The New Delta ApparelsLtd

31st May 2014

Observations

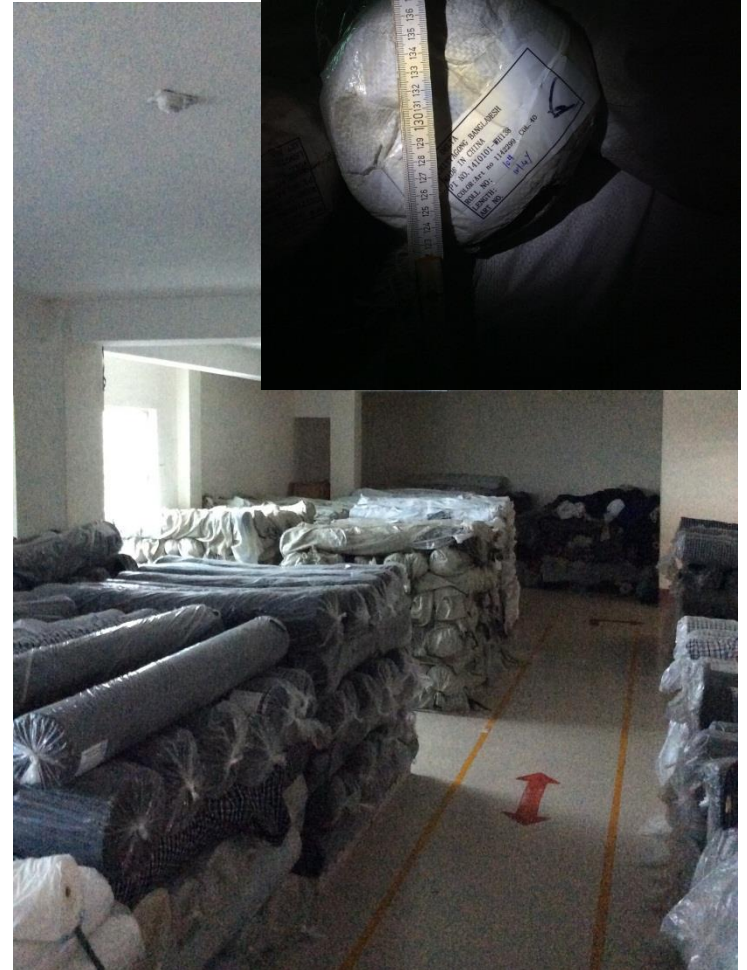
**High stress levels in Perimeter Columns
where slabs have been extended beyond
the design/permit drawings.**

Large storage loading on Cantilever slab.

Large build-up in toilet area's on Cantilever slab.

Cantilever slab.

**Heavily Loaded cantilevered slabs.
(toilet build up, storage, heavy machinery)**

Discrepancies between Drawings and Actual Observations

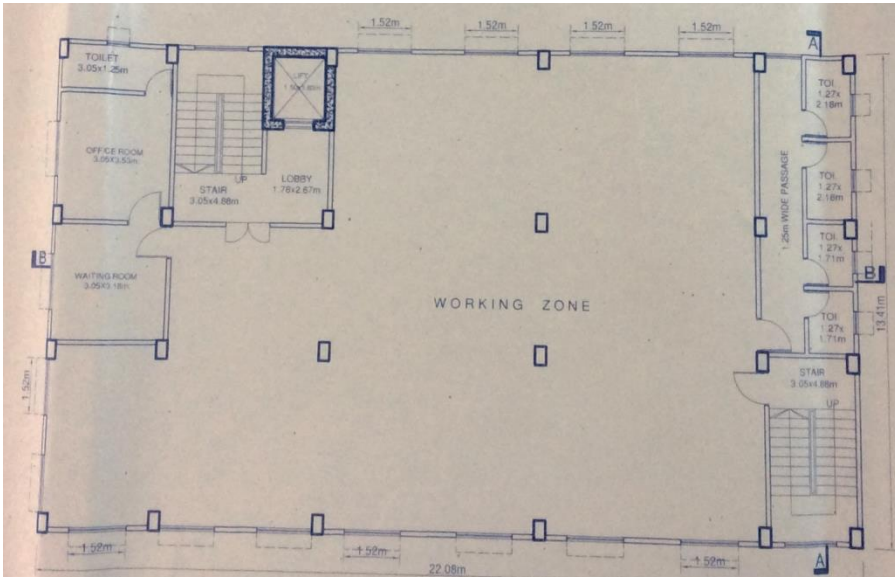
These columns do not exist from first floor to roof level.

Permit Drawing, no Cantilever Shown

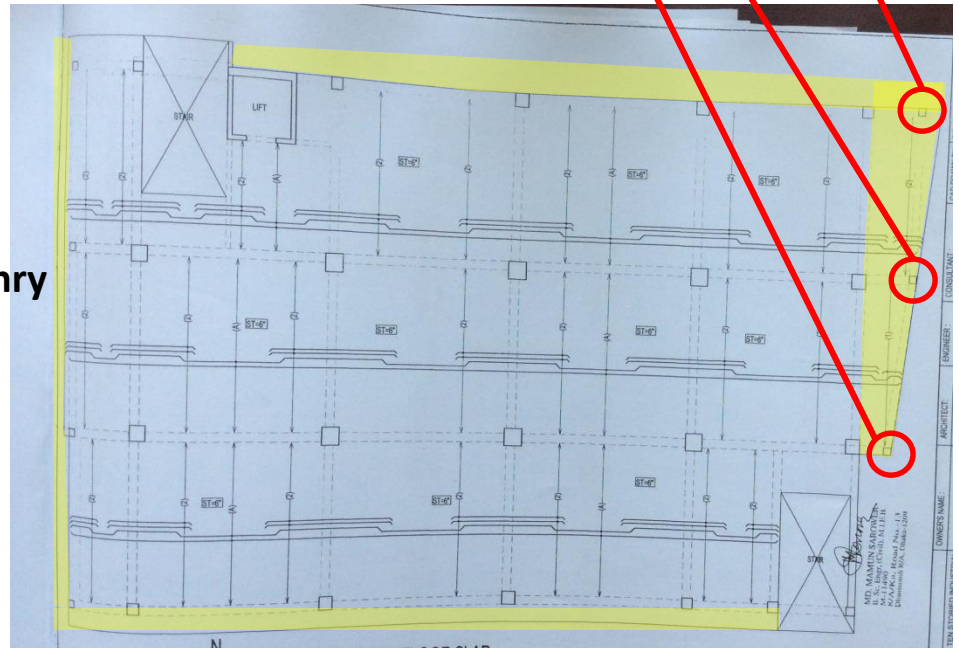
Denotes undocumented Cantilevers (may be supported on masonry wall)

Structural Drawing, no Cantilevers Shown

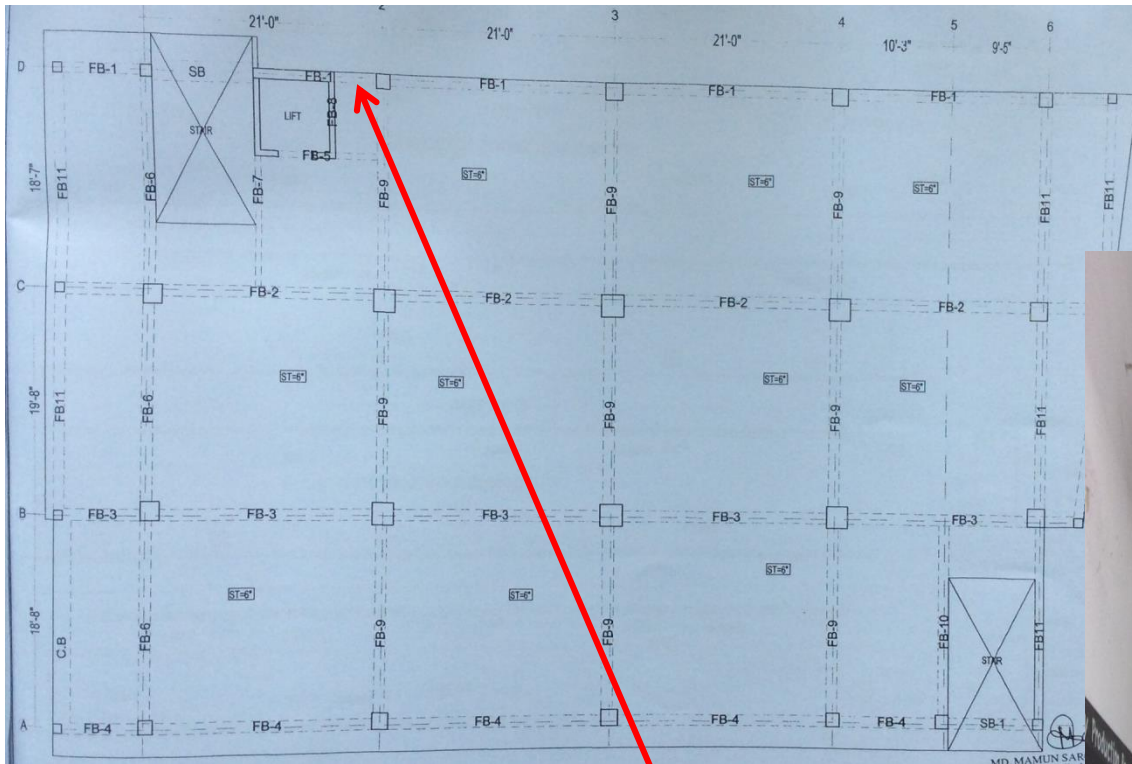
**Beam shown on plans
Missing in as constructed
Building at 2nd floor.**
